**REQUEST FOR BID 2860-05A, 2860-05B, 2860-05C, 2860-05D
W 76 Country Blvd Streetscape – Segments 1 and 2**

Addendum No. 4

Addendum NO 4

FOR: W 76 Country Boulevard Streetscape Improvements,
Contracts EN7622, SNS0032 &
W 76 Country Blvd Median Improvements
Contracts TAP-9901(886) and STP-0761(023)
GRE Project 4515

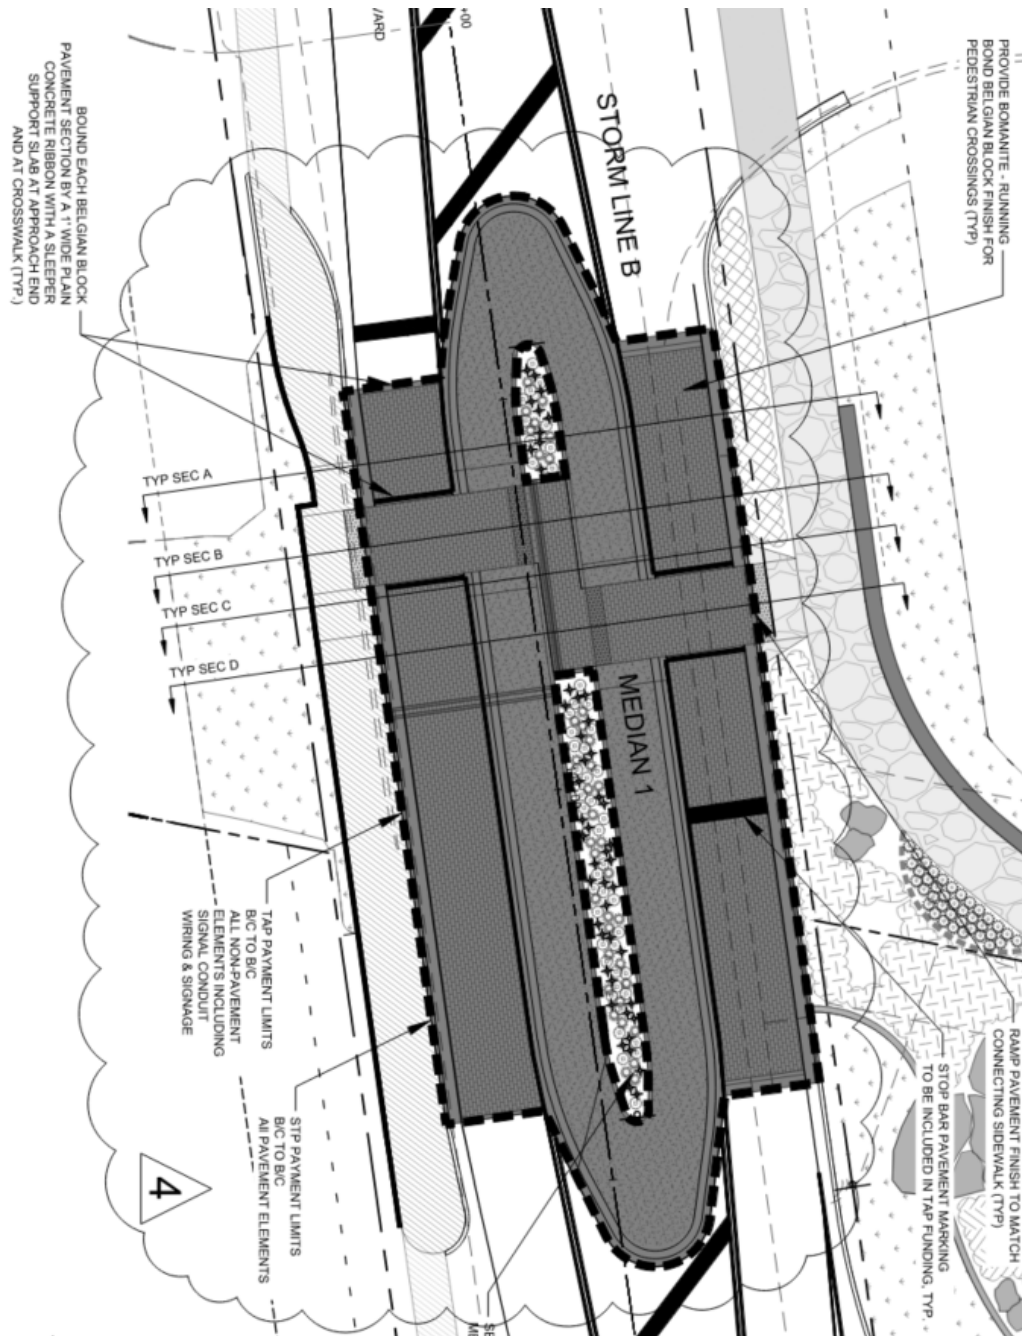
1. Change Contract Bid Items – STP-0761(023) Elements will include all median improvement pavement elements. TAP-9901(886) Elements will include all non-paving median improvement elements.
 - a. Delete TAP-9901(886)/STP-0761(023) Plan Sheet 7 of 34
 - b. Revise TAP-9901(886)/STP-0761(023) Plan Sheet 6 of 34
 - i. Delete Note 7.

7. ~~TRUCK APRON PAVEMENT, SEE SHEET 07 FOR STP PAY LIMITS.~~
8. CONTRACTOR SHALL PROVIDE PAVEMENT IMPRINTING PATTERNS, MATERIAL AND MOCK UPS FOR APPROVAL PRIOR TO INSTALLATION.

- ii. Revise Pay Limits as shown below (Sheet following).
